National Fire Protection Association

MEMORANDUM

SUBJECT: NFPA 1981 ROP TC Letter Ballot (F2012)

Attachments: Proposals
Letter Ballot

1981, Log 7, Figures 1A, 1B, 2A, 2B, 3, 4

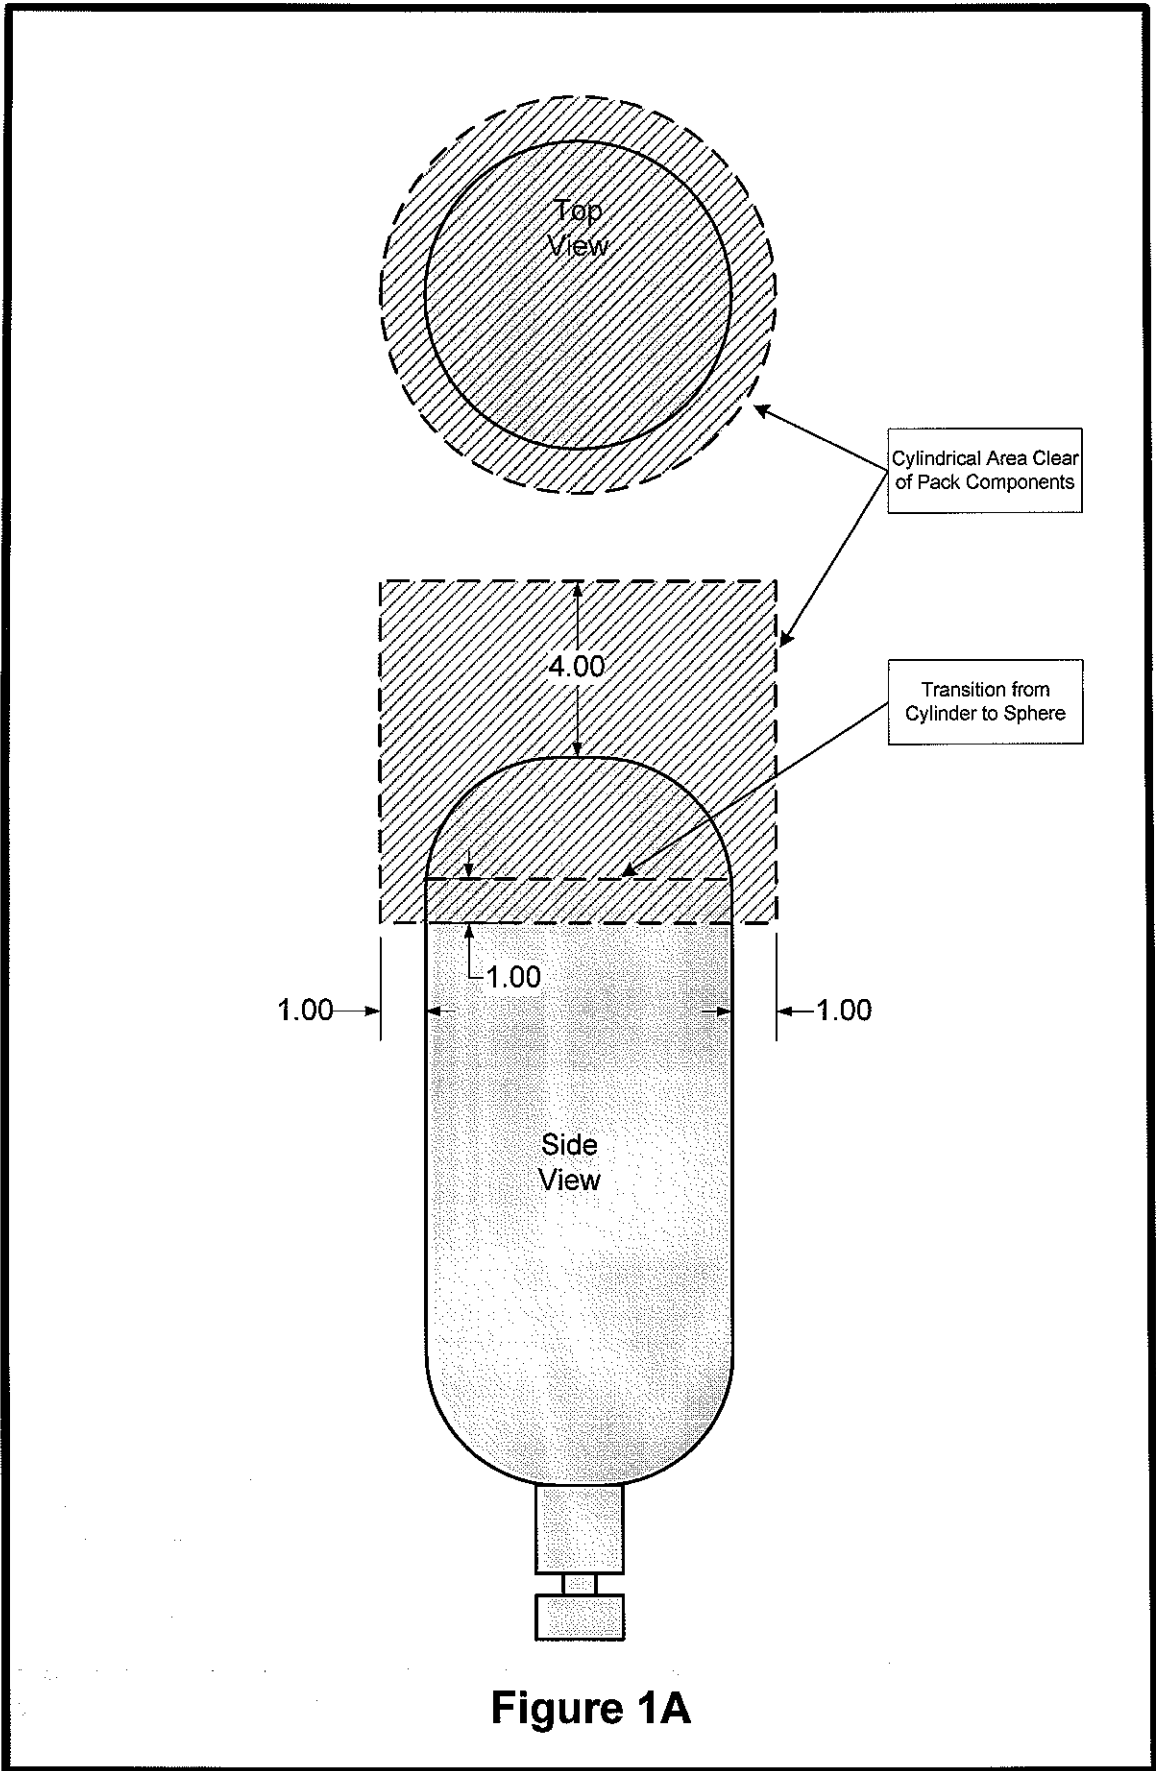
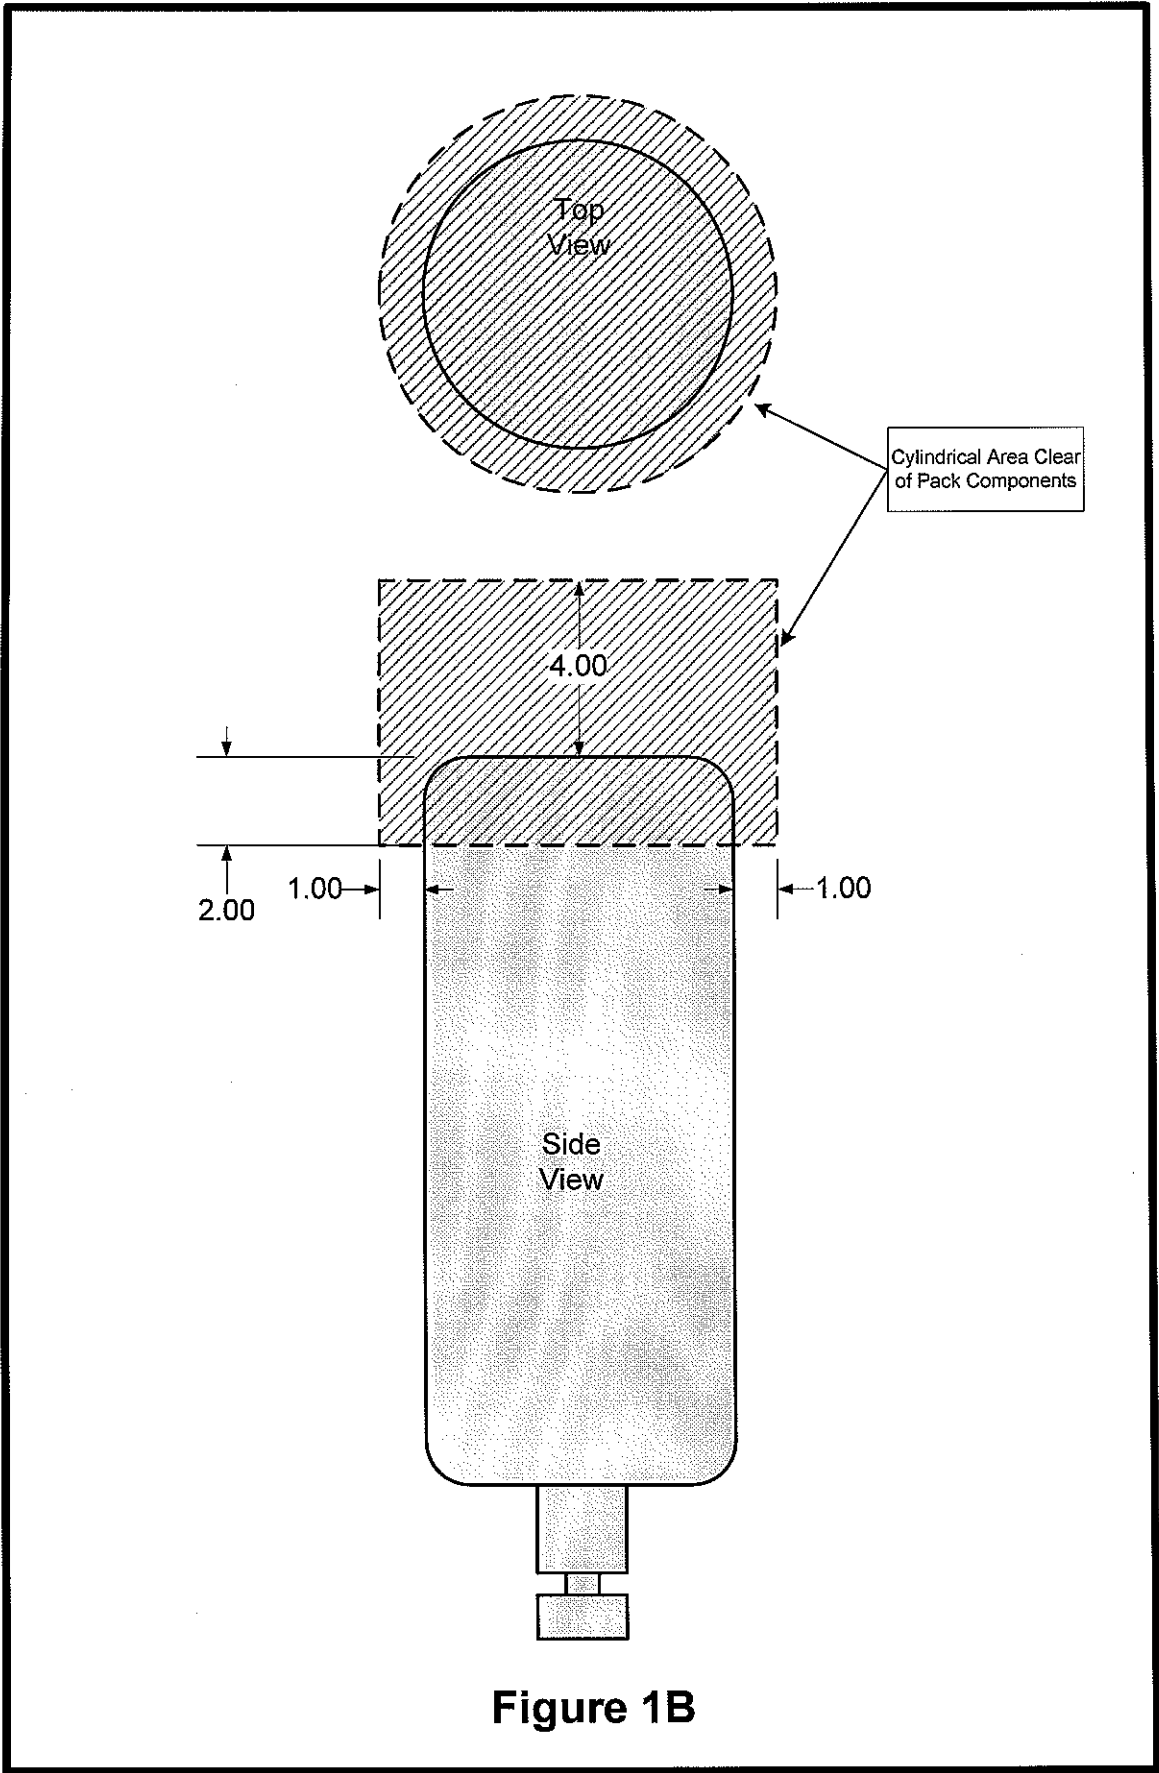
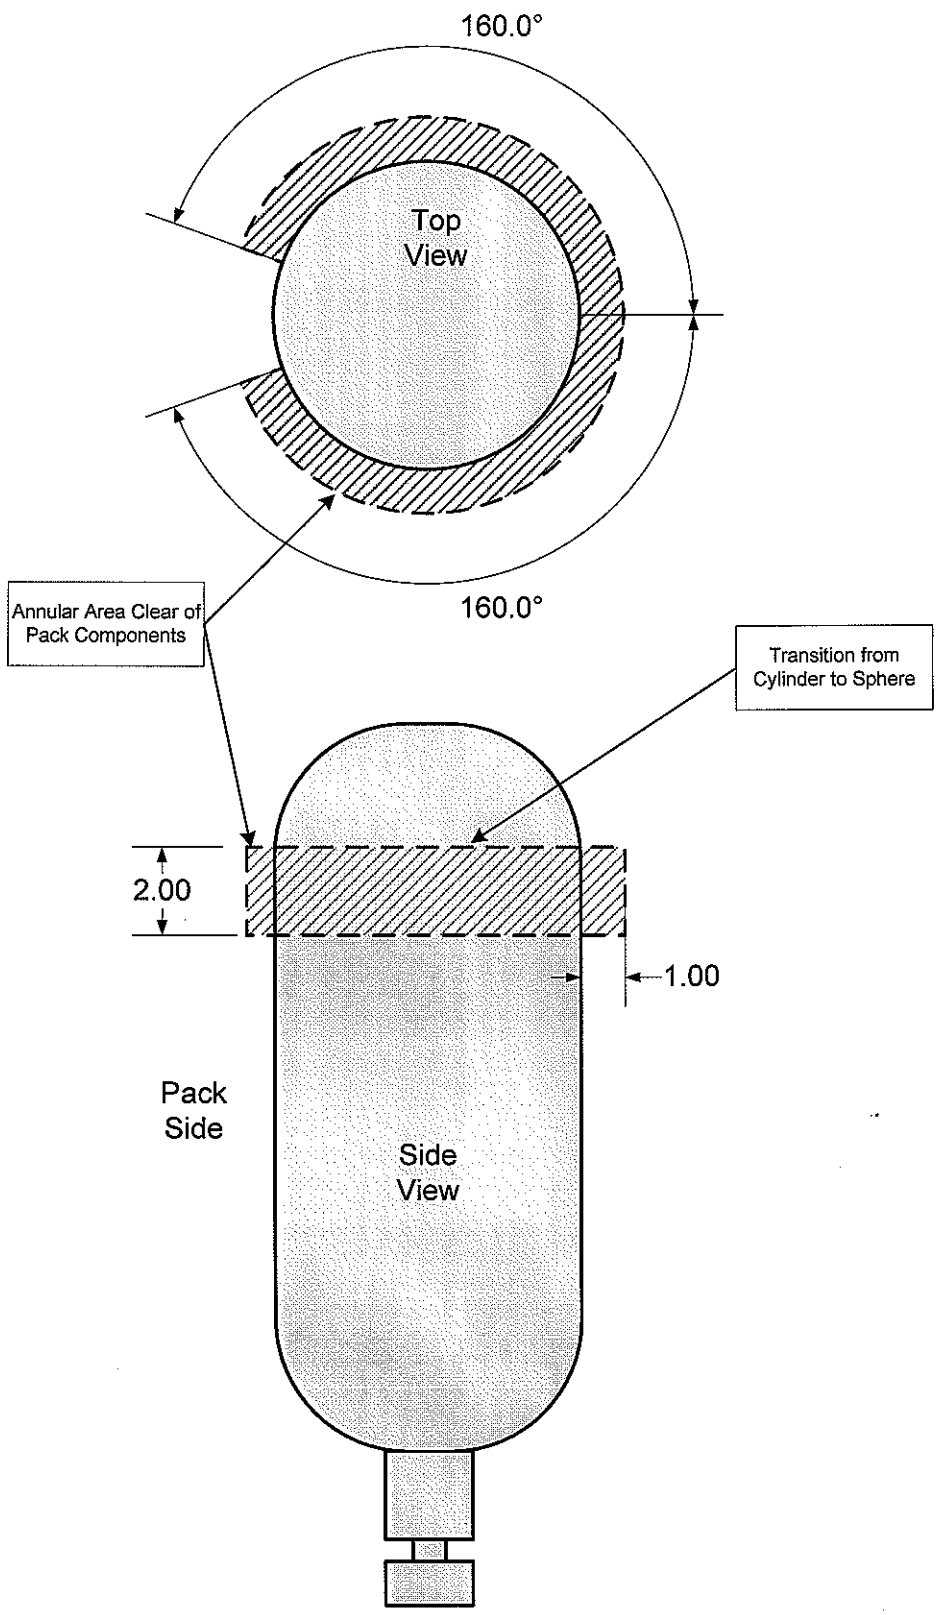
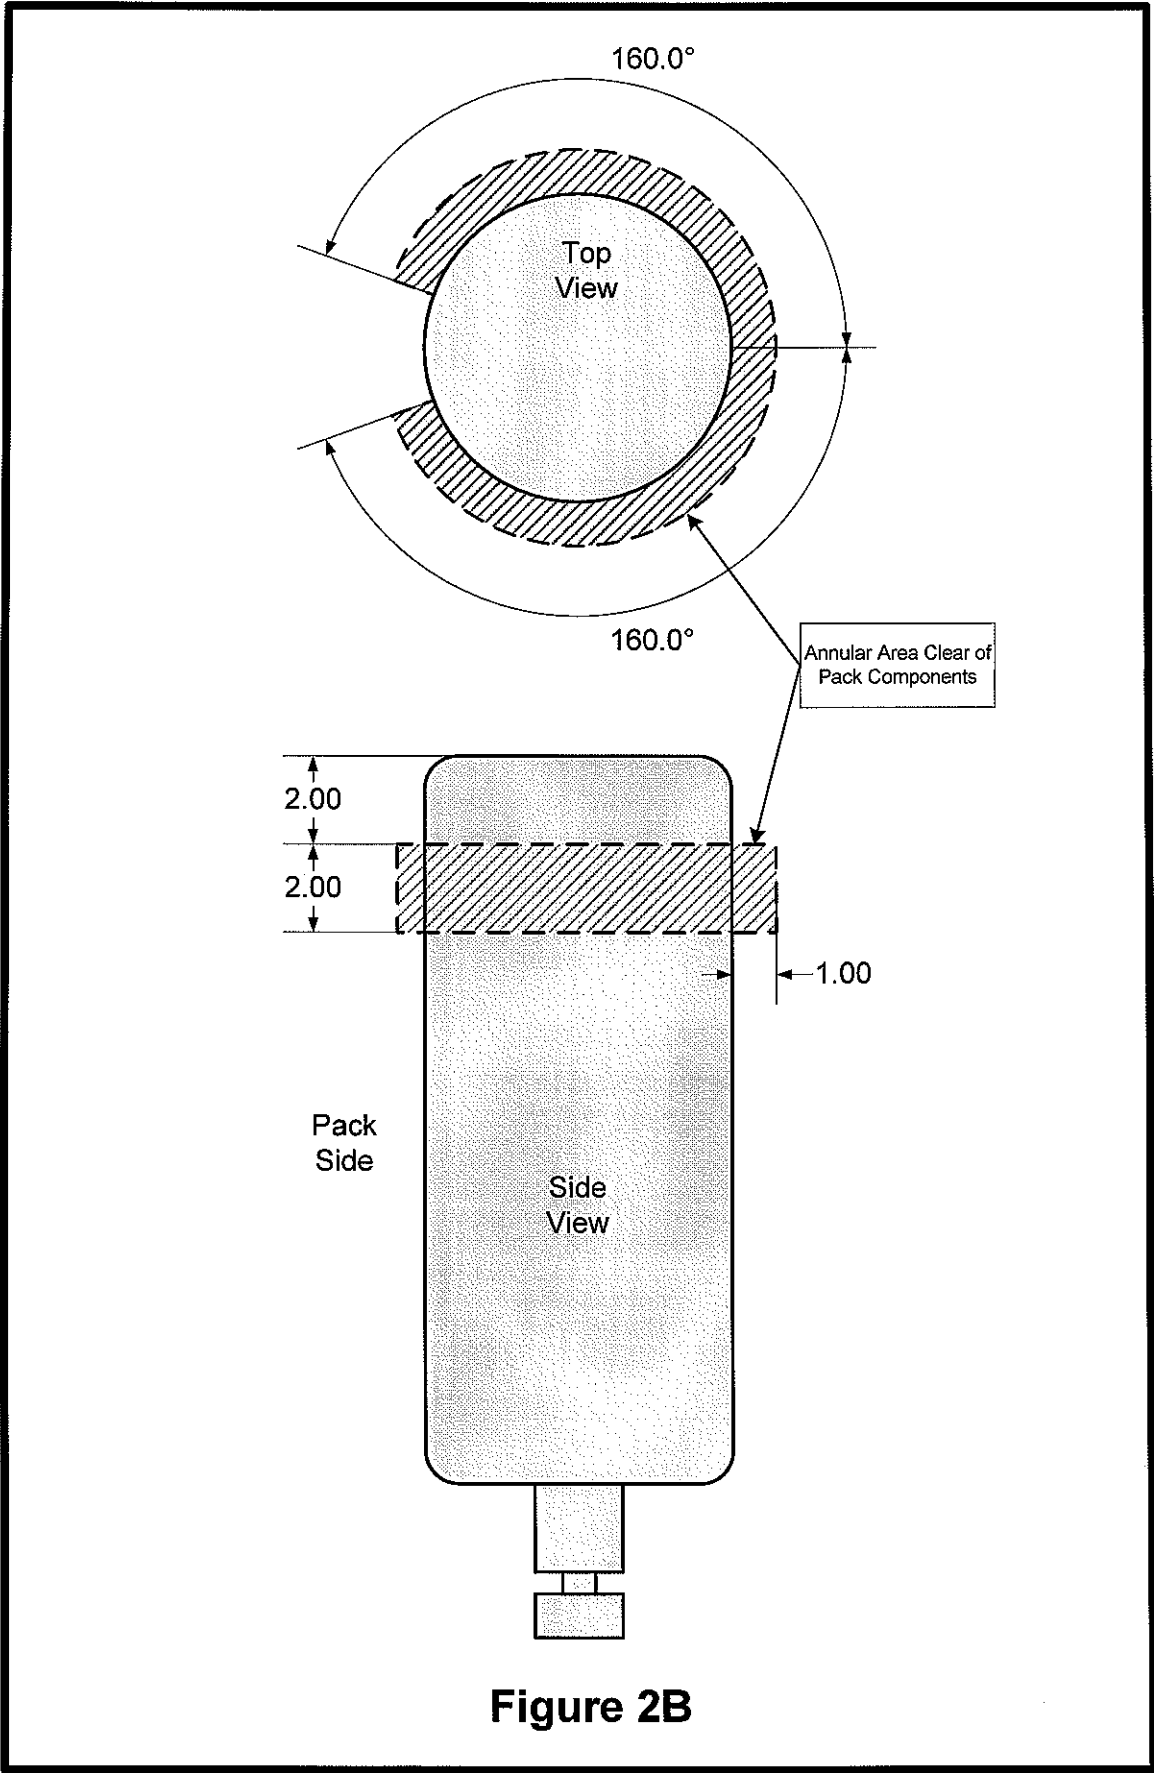
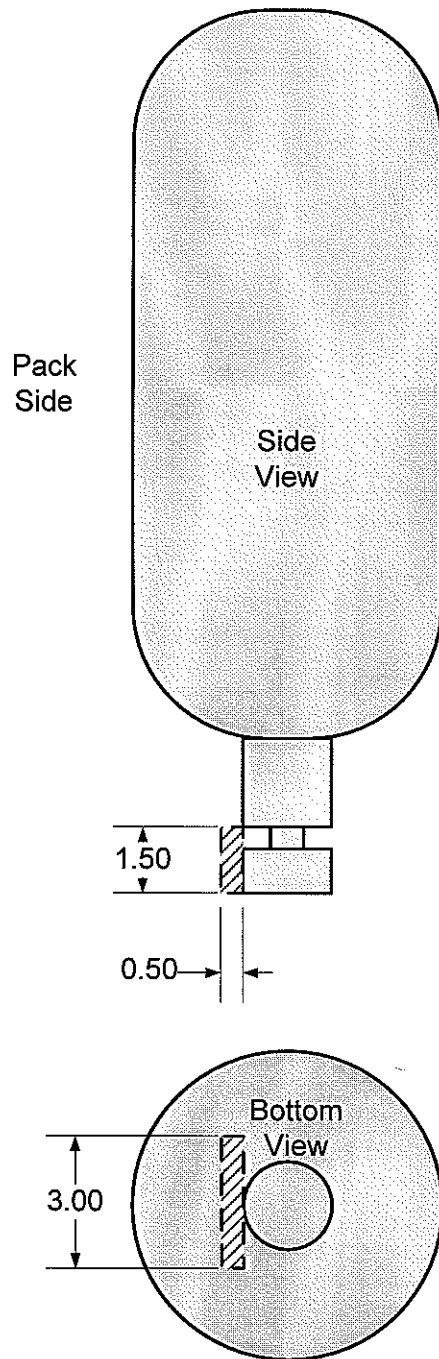
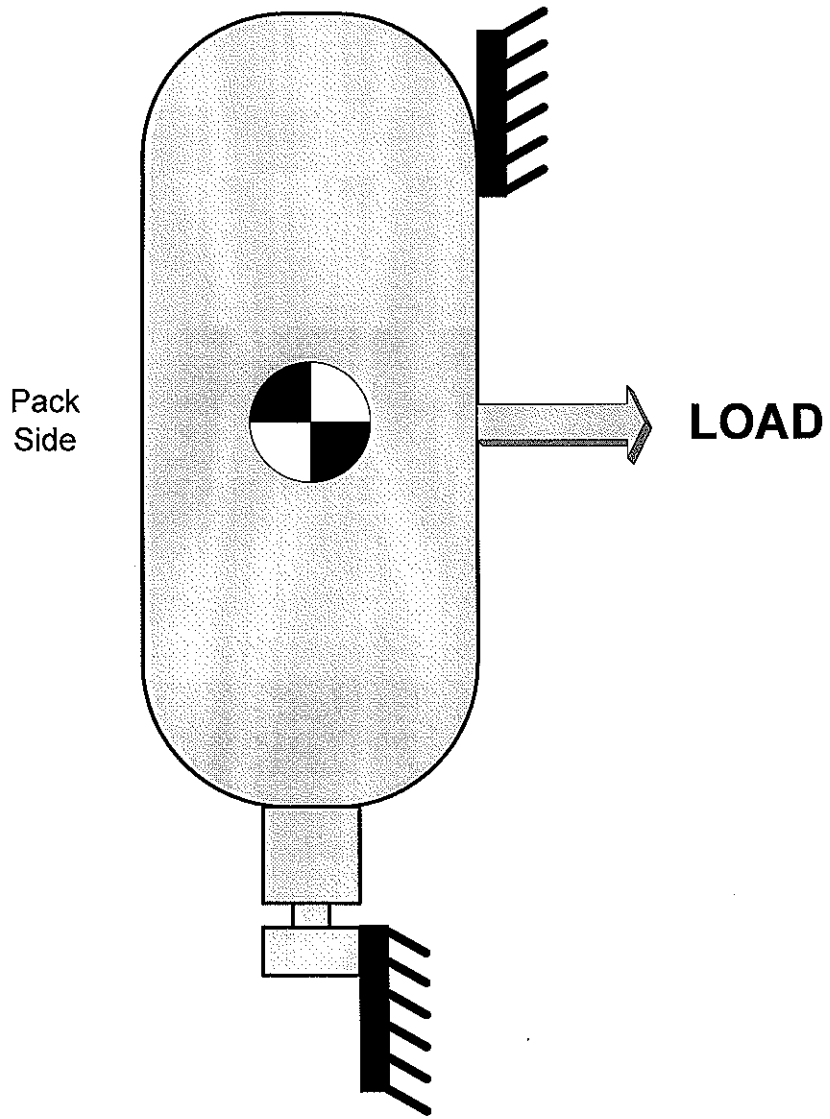
6.7.2 Each SCBA shall maintain a clear annular area concentric with the bottle, one inch greater in radius than the bottle radius, and 2 inches in height beginning at the back of the SCBA bottle and sweeping 160 degrees both clockwise and counterclockwise around the bottle. This clear annular area shall be located vertically on the bottle beginning on the plane at which the spherical top of the bottle transitions into the cylindrical body of the bottle, and extending downward (see fig 2). This area may overlap with the clear area specified in paragraph 6.7.1.

6.7.5 The SCBA bottle valve shall remain attached to the bottle without damage when a force of 20 times the weight of the bottle and pack is exerted at the CG of the SCBA for 10 seconds with the SCBA being retained by a fixture that grips the top of the bottle and the extreme end of the valve (see figure 4).

The 80 lb extraction force criteria is based on actual measurements of various SCBA holders on the market. As a base-line, the old "broom-clip" style bottle holders require 35 lb extraction force. This value also seems reasonable since the weight of the bottle and pack can weigh as much as 35 lbs, and the pack should survive continually pulling of at least twice its own weight so that it can last through the riggers of use at the fire scene.

The SCBA is commonly secured into the holder by gripping the bottle at the top, and the valve at the bottom. Although testing indicates that the typical bottle valve is more than strong enough to withstand the retention forces using this method of gripping, there does not appear to be any minimum valve strength criteria in the standard. Acceptance of this proposal will assure that future valves would always be strong enough to be treated in this manner without damage. The 20 g factor matches the value used in FMVSS 207 for retention of seating systems. The logic for this value is that if the
